Dominion Nuclear Connecticut, Inc.
Millstone Power Station
Rope Ferry Road
Waterford, CT 06385

**Millstone Power Station
Cooling-Water System Technology Study
Winter Flounder Mass-Balance Model - Review by ESSA Technologies Ltd.**

Enclosure 1 to Letter No. D17404

DNC Comments on the Review of the Millstone Power Station Larval Winter Flounder Mass-Balance Model Performed by Greig et al. (2002)

Fig. 1. Comparison of estimated CMR of Niantic River larval winter flounder from entrainment at MPS as given in DNC (2001b: Table 39, pp. 255-256) with a revised calculation based on increasing egg survival from 20% to 50% during the years 1995 through 2001.

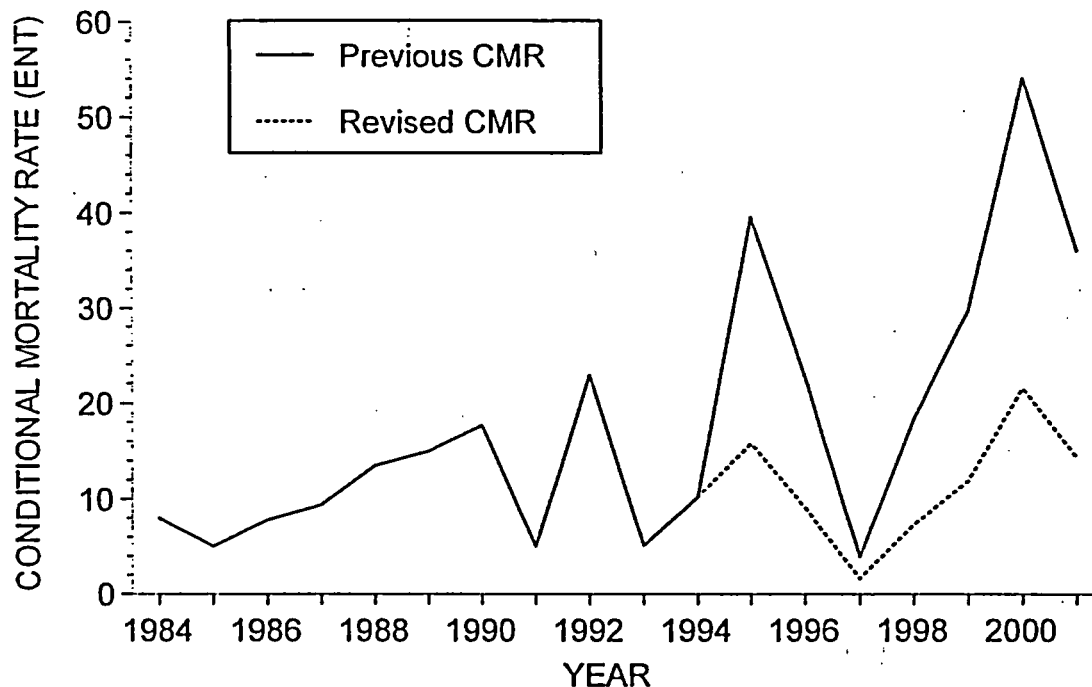
Section 2.2, Subsection 2.2.1 - Page 4, Paragraphs 1 through 3 - The trend in ENT (production loss or CMR, which is used by Greig et al. 2002) and the "puzzling" fact noted by Greig et al. (2002) that larval abundance has not declined in a fashion consistent with low adult spawner abundance can be explained if the compensatory decline in egg mortality hypothesis is real. The data leading to this conclusion are found in DNC (2002b: Table 39, pp. 255-256) and shown graphically by Greig et al. (2002: Fig. 1, p. 5), which shows a recent increase in annual estimates of CMR. Also, the estimated 82.2-89.6 million larvae assigned to the Niantic River by the MBM in the last 2 years (DNC 2002b: Table 39, pp. 255-256; corrected for Stage 1 entrainment) appeared to be at odds with the low adult population size and egg production estimates. These observations are consistent with density-dependent theory (e.g., Hilborn and Walters 1992) in that less egg deposition results in lower egg mortality, likely from predation, and thus, a higher hatching rate that results in more Stage 1 larvae. The relatively large number of larvae available for entrainment in 2000 and 2001 were also probably a result of the very low larval mortality rates in those years (DNC 2002b: Table 15, p. 204), leading to high densities in Niantic Bay (DNC 2002b: Table 15, p. 193). Low larval mortality, at least in 2001, likely was the reason for very high settling densities of demersal juveniles that year (DNC 2002b: Fig. 26, p. 207). As for the trend in ENT, the higher than average CMRs seen since 1995 coincide with the higher (except for 2000) than expected numbers of Stage 1 larvae observed in the Niantic River during the same years. Yet, in the calculation of production loss, unlike the calculated annual stage-specific larval mortality rates, the egg mortality rate ($M_{egg} = 1.61$, equivalent to a survival rate of 20%) has not been varied by year. This makes the calculation of Niantic River stage-specific abundance (the denominator in the production loss calculation) lower than it should be if egg mortality rates were reduced under low adult spawning stock sizes. As noted in DNC (2002b: p. 254), this would make the calculation of production loss conservatively high, perhaps by a factor of 4 or more. However, if the annual egg survival rate for the years 1995-2001 is increased somewhat arbitrarily from 20 to 50%, which is a reasonable assumption, then the CMR time-series resembles historical rates (Fig. 1), fluctuating around a revised geometric mean value of 9.6%.

Fig. 2. Numbers of entrained winter flounder larvae attributed to the Niantic River as determined by DNA analysis (solid line) and the MBM (dashed line) in 2001 and 2002.

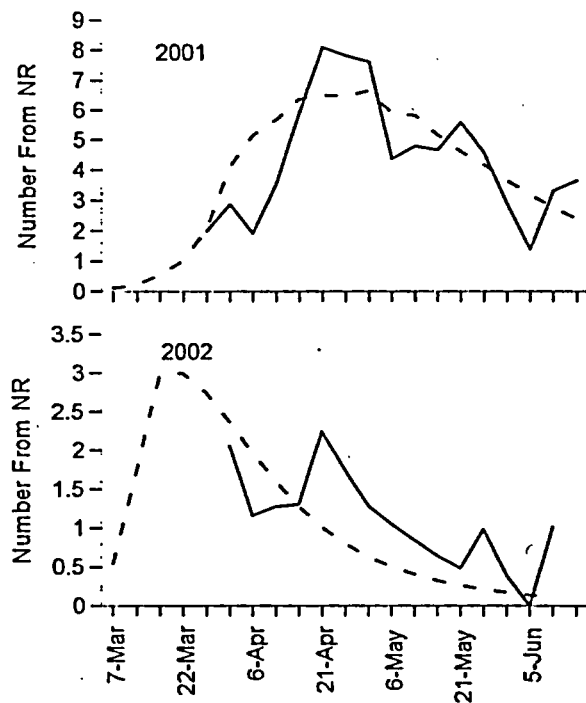
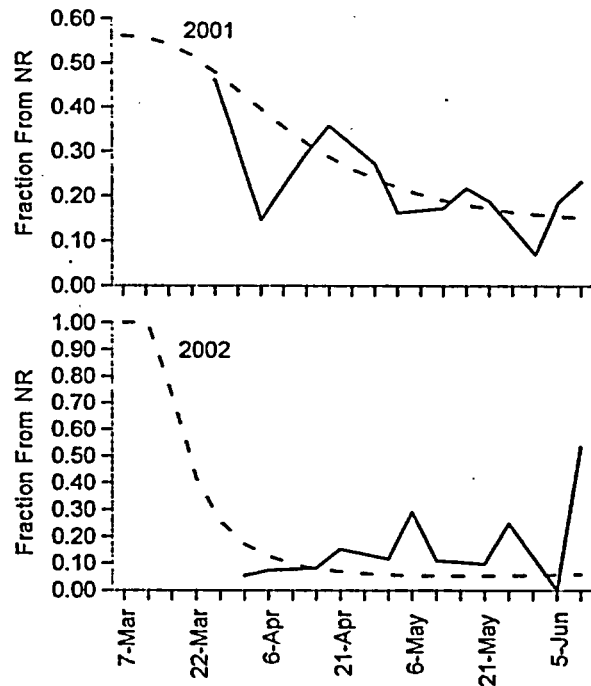
Section 6.2, Page 51, Text Paragraph 3 - Greig et al. (2002) note the possibility of using DNA or microelement typing to assess the relative contribution of larvae from different stocks of winter flounder at NB. We do not believe that this effort is warranted. The direct measure of larval stock identification at the MPS is preferable to measuring the components at NB to verify the indirect estimates of entrainment made using the MBM. We were puzzled why the DNA analysis of larvae entrained at MPS performed by Dr. Joseph Crivello of the University of Connecticut was not mentioned in Greig et al. (2002). This work provided a direct estimate of the fractions of larval winter flounder entrainment at MPS attributed to the Niantic River spawning stock and stocks located in the Thames River and just west of the Connecticut River. The report of Crivello (2002) was sent to DEP via DNC (2002a) and to both DEP and ESSA by DNC (2002c). The latter submission also included pages 251-254 of DNC (2002b), where the findings of the Crivello (2002) DNA analysis for 2001 samples (1,067 entrained larvae) were compared to MBM results. This comparison (DNC 2002b: Table 38, p. 253) showed that the fractions of larvae attributed to the Niantic River were virtually identical from DNA analysis (22%) and the MBM (21.4%). Certainly, there was some variation in timing of Niantic River larval entrainment between the two methodologies (see DNC 2002b: Fig. 45, p. 254), possibly related to the point samples taken for DNA analysis and the relatively smooth curve generated by the MBM. However, the highly similar end results lend much credibility to the MBM.
